REQUEST

Current Zoning: O-2 (office) and MUDD-O (mixed use development, optional)
Proposed Zoning: MUDD-O (mixed use development, optional) and MUDD-O SPA (mixed use development, optional, site plan amendment) five-year vested rights

Approximately 3.4 acres bounded by East 3rd Street, East 4th Street and the southeast side of Baldwin Avenue.
(Council District 1 - Egleston)

SUMMARY OF PETITION

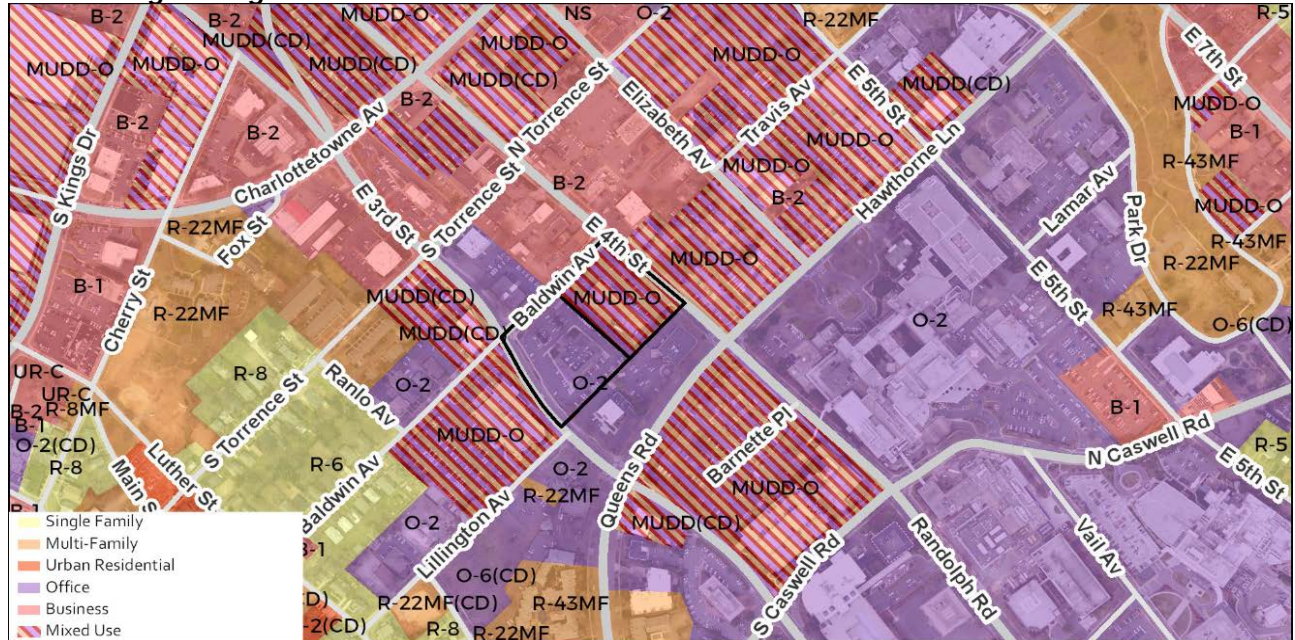
1. Modify, clarify, and provide examples for Note 3 ii under Design Guidelines for innovative

landscaping.

2. Petitioner should provide and construct a new bench pad for the existing bus stop on East Fourth Street along this site's frontage.

3. The proposed zoning district has a setback measured from back of the existing or proposed future curbline. The location of the future back of curb on 3rd and 4th is eight feet behind existing curb for a future bike facility. The existing curbline on Baldwin is in the future location. These curbline definitions do not include mitigations to be identified by the traffic impact study.

- a. Intersection improvements likely needed to support this project include
 - i. Left turn lane from Fourth Street at proposed driveway(s) and onto Baldwin

- ii. Signal at 4th and Baldwin
 - b. Ten and ½-foot minimum lane widths on 3rd street frontages
 - c. Ten-foot minimum lane widths on 4th street frontages

- d. Ten-foot minimum lane widths on Charlottetown between 3rd and 4th and reserve space for buffered bike lanes
 - e. Construction/reconstruction of bike facilities, planting strip, and sidewalk is expected with any/all lane improvements and curbline relocations.

4. The petitioner should revise the site plan and conditional note(s) to provide internal circulation within parking deck to each public street access point (e.g. can enter on 4th and exit on Baldwin).

5. The petitioner should revise the site plan and conditional note(s) to show future curbline around entire site.
6. The petitioner should revise the site plan and conditional note(s) to provide a minimum eight-foot planting strip, eight-foot sidewalk, and eight-foot buffer to building behind the future curbline.

7. Label and dimension the existing or future back of curb on the site plan for all public streets around the subject property.
